From: ADG Architecture IIc

Project Number: 2023-J-135

RE: Bidding RFI #2 Responses

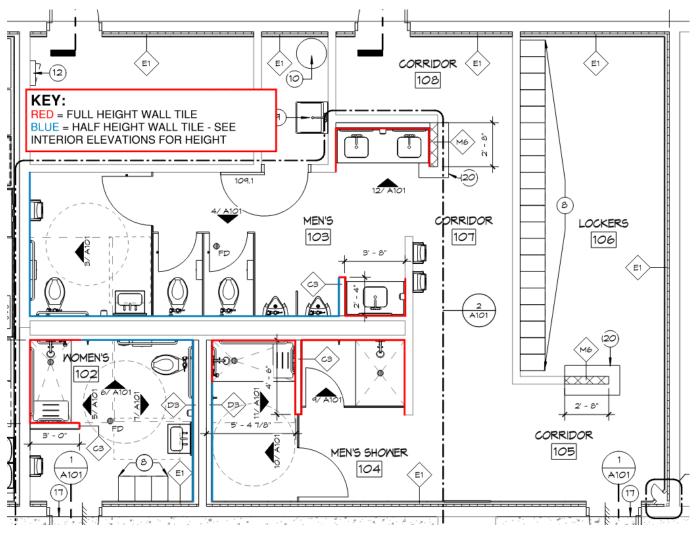
QUESTION: Do you have a preference for tiles to be installed?

RESPONSE: The preferred wall tile format is 4" x 4" glazed porcelain tile. The preferred floor tile format is 4" x 4" porcelain tile. Tile color and pattern to be determined by owner. Acceptable tile manufacturers are listed on sheet A902. For clarity, below is a markup illustrating the locations of new wall tile.
